Summary of Changes

Elaine Battery Energy Storage System (BESS)

Project:	Elaine Battery Energy Storage System (BESS)
To:	FRV - Jennifer Blyth
From:	NJM Design - Javier Piedrahita
Project number	8022
Subject:	Summary of changes
Date:	12 January 2024

Figure 2: Access roads

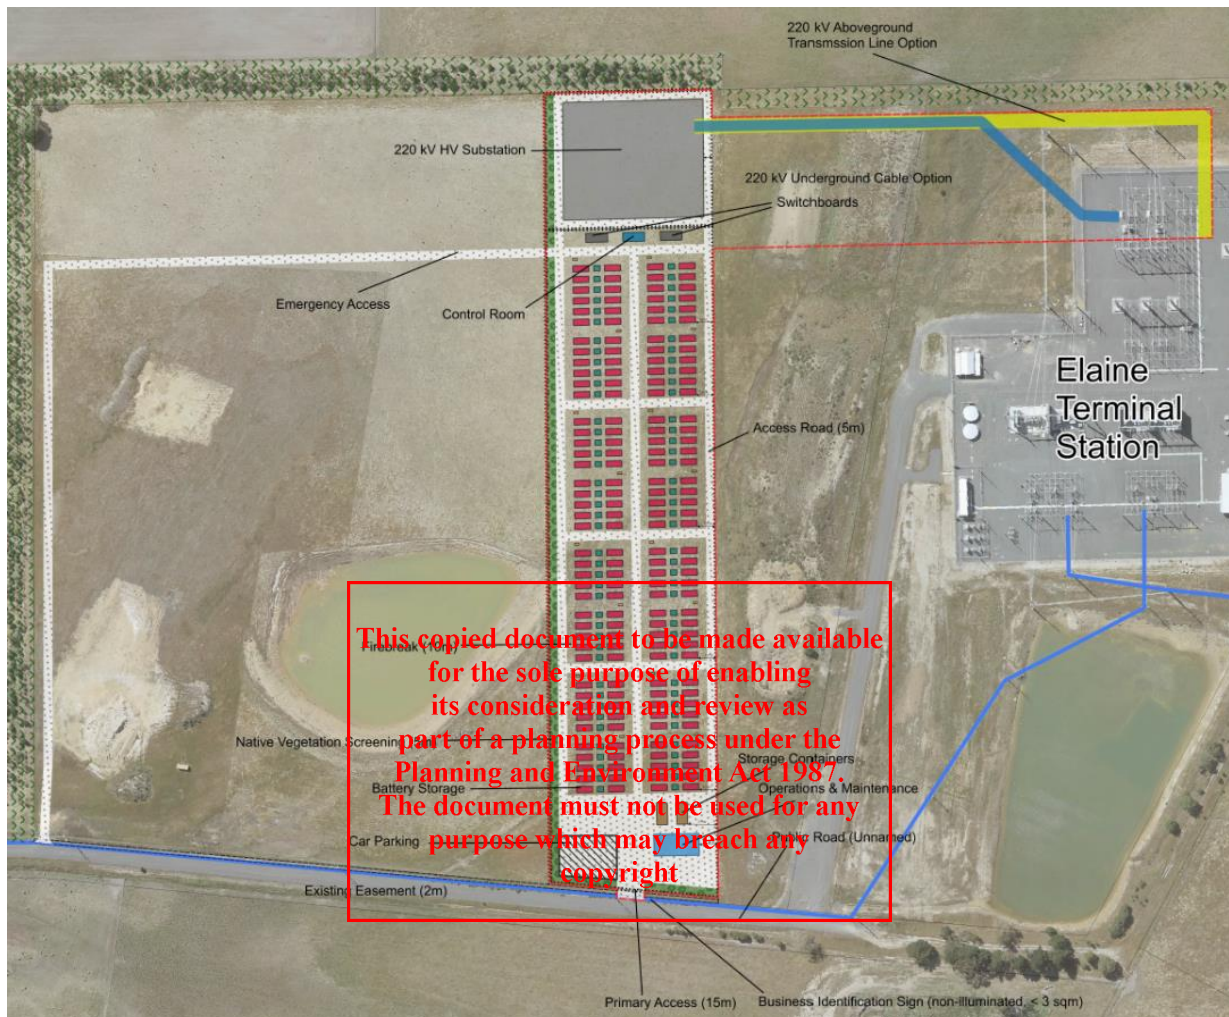
2. Fire Brigade Access (updated information):

The site has a safe access point direct from Murphys Road on the south-east side of the allotment and a secondary emergency access on the south-west side of the allotment, furthermore, there will be an alternative entrance to be used for emergencies located on the north-west side of the allotment (Figure 2).

Figure 3: “Yard area” definition.

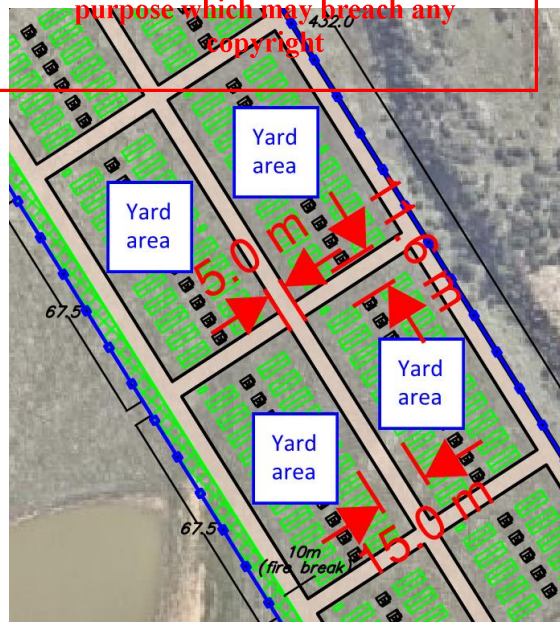
For the purpose of this assessment and given the previous fire spread risk review (see section 6.2, which demonstrates that fire spread is not likely within 10m from the BESS battery), the “yard area” will be defined as one of the battery arrays that are separated by a 5m wide road (see Figure 3).

Each one of these battery arrays has an average area of between 2,400m² and 2900 m² (i.e., < 3,000m²), and each 220kV HV transformer yard is approximately 2,500m² (i.e., < 3,000m²). Accordingly, 1 hydrant running for 4 hours is required by the AS 2419.1-2005 for a BESS.

The water storage tank is therefore required to allow for 1 hydrant at 10L/s each for four hours, i.e., 144kL.
